DRAWING NO. D2724	TITLE 206L/407 STEP ASSEMBLY	REV. C	DART AEROSPACE LTD ENGINEERING ORDER		D.E.O. NO. D2724-C-1	SHEET NO. SHEET 1 OF 1	SCALE NTS
DRAWN AJS	CHECKED		MFG. APPR.	APPROVED		DE APPR.	
DATE 14.12.09	DATE		DATE	DATE		DATE

REF PAR 14-355

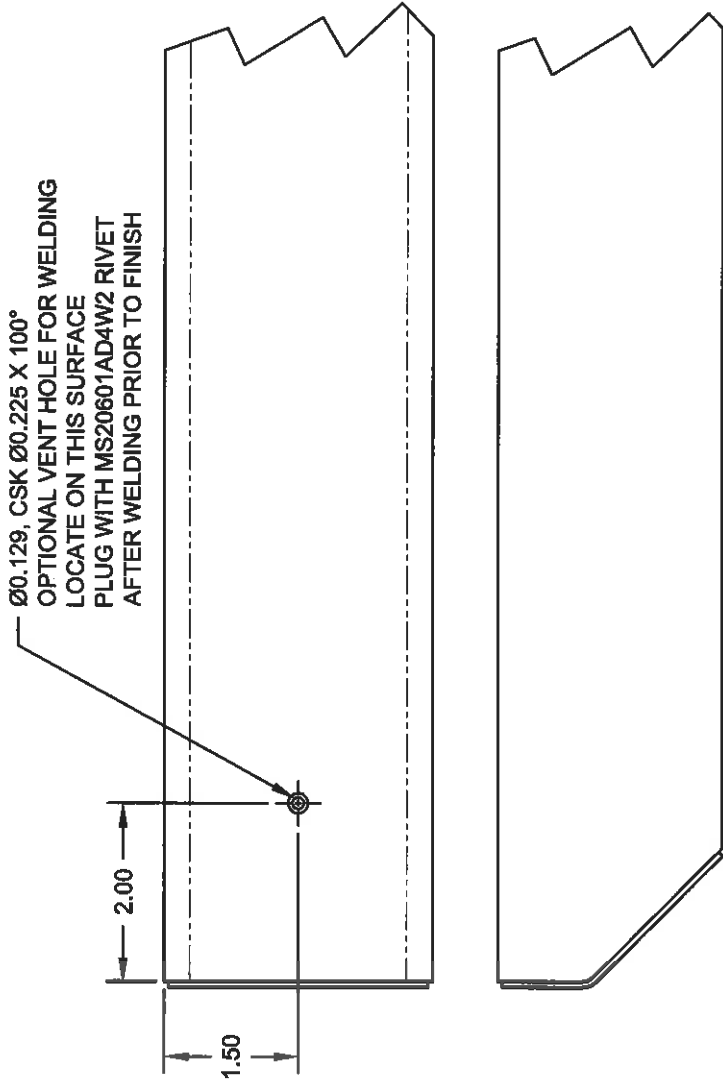
ADD VENT HOLE AND MS20601AD4W2 RIVET AS SHOWN BELOW:

ADD MS20601AD4W2 RIVET TO PARTS LIST AND CORRECT TYPO AS SHOWN:

IS: D2724-041/-042 STEP ASSEMBLY PARTS LIST

WAS: D2721-041/-042 STEP ASSEMBLY PARTS LIST
